Intersection ID: 31236	Main Street: AVONLEA_CT	Cross Street: STEEPLEGLLEN_CT	Location:	NW
ADA ID: DE685F667DFD	Ramp Type: PerpDiag	Initial Pass/Fail: Fail	Overall Compliance: No	Severity Score: 8.75

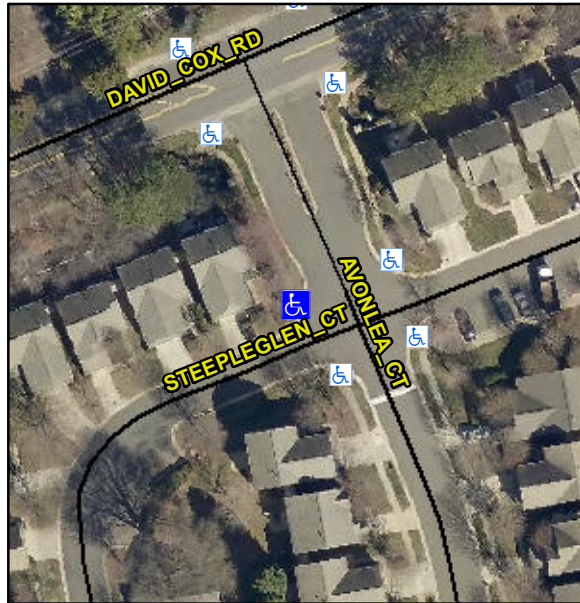
Not Found, R304.5.1

Compliance	Description	Data	Compliance	Description	Data
N/A	Ramp Length (in)	46.5	Yes	Ramp Slope (%)	5.9
No	Ramp Width (in)	45.0	Yes	Ramp XSlope (%)	0.9
N/A	Flare Type LT	N/A	N/A	Flare Type RT	N/A
N/A	Flare Slope LT (%)	N/A	N/A	Flare Slope RT (%)	N/A
N/A	Flare Traversable LT?	N/A	N/A	Flare Traversable RT?	N/A
N/A	Landing Length (in)	N/A	N/A	DWS Provided?	N/A
N/A	Landing Width (in)	N/A	N/A	DWS Contrast?	N/A
N/A	Landing Slope (%)	N/A	N/A	DWS Length (in)	N/A
N/A	Landing X Slope (%)	N/A	N/A	DWS Full Width?	N/A
N/A	Landing Curb? (Y/N)	N/A	N/A	DWS Offset (in)	N/A
N/A	Shared Landing?	N/A			
N/A	Gutter Ponding?	N/A	N/A	Gutter Slope (%)	N/A
N/A	Gutter Lip Ht (in)	N/A	N/A	Gutter X Slope (%)	N/A
N/A	Painted X Walk1?	No	N/A	Painted X Walk2?	No
	X Walk 1 Direction	To S		X Walk 2 Direction	To E
N/A	X Walk 1 Width (in)	N/A	N/A	X Walk 2 Width (in)	N/A
	X Walk 1 Slope (%)	0.7		X Walk 2 Slope (%)	1.0
	X Walk 1 X Slope (%)	0.4		X Walk 2 X Slope (%)	0.1

Remove & Replace Curb Ramp With Two New Directional Ramps or Equivalent.
